PITEAU ASSOCIATES
GEOTECHNICAL AND
HYDROGEOLOGICAL CONSULTANTS

November 9, 1991

Re: Geotechnical Review of Faro and Vangorda Pits

FIG. 1

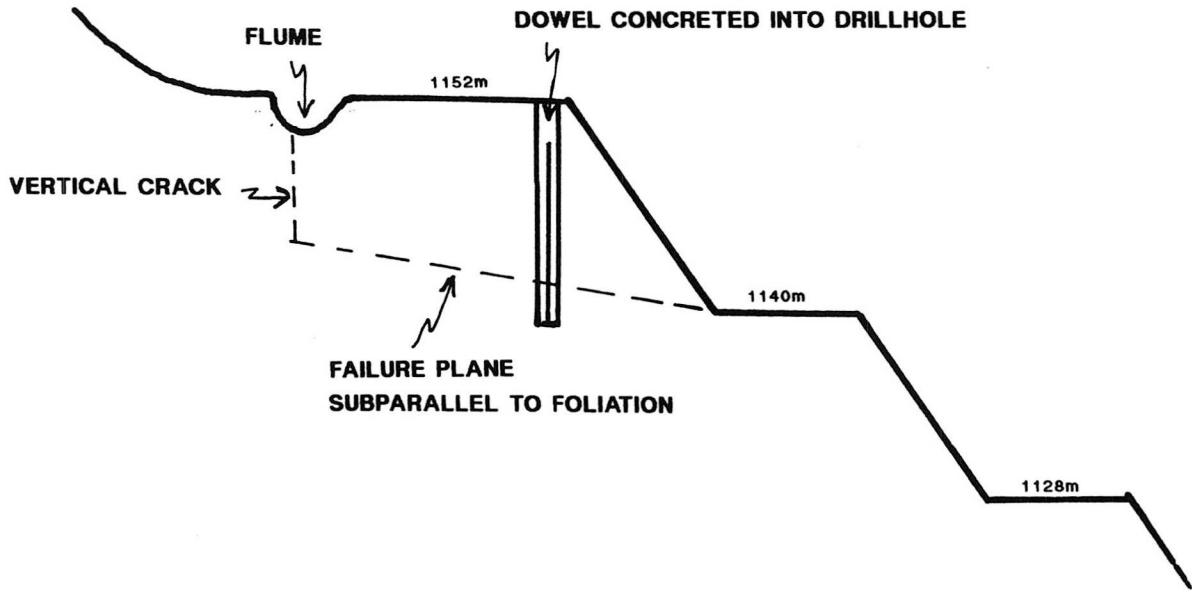
For purposes of determining the lateral spacing of the dowels, it has been assumed that a failure plane could extend upward at a dip of 10° from the toe of the 12m bench below the flume (see Fig. 1). It is also assumed that a vertical crack could form the back scarp of the failure, and that this crack and the failure plane could be subject to water pressure due to leakage from the flume, and/or general groundwater seepage. Based on a lower bound estimate of shear strength equivalent to the dip of the failure plane, it is conservatively estimated that the lower bound factor of safety could be about 0.75. To increase the factor of safety to 1.5, additional shearing resistance equivalent to about 70 kips/ft of slope would be required.

While the specifications for the "95 lb" rails are unknown, it is assumed that the rails may have an ultimate shearing strength of about 80 kips/in² and a cross-sectional area of about 9 in². Assuming the concrete does not provide any shearing resistance, each dowel would have an ultimate capacity of about 720 kips of shearing resistance. Thus, the recommended lateral spacing between vertical rail dowels would be about 10 ft (i.e. 720 kips/70 kips per ft = 10.3 ft). Before beginning installation of the dowels, it is very important that the actual shearing strength and cross-sectional area of the dowels be determined. If they are different than the parameters assumed above, a revised dowel spacing must be calculated.

With regard to installation of the row of dowels, it is recommended that they be installed within 2m of the crest of the slope. If possible, the bars should be approximately centred in the holes (possibly by spot welding two or three spacers on each end of the bar) before the concrete is poured into the hole. The dowels should be installed prior to blasting and excavating the rock from the bench below.
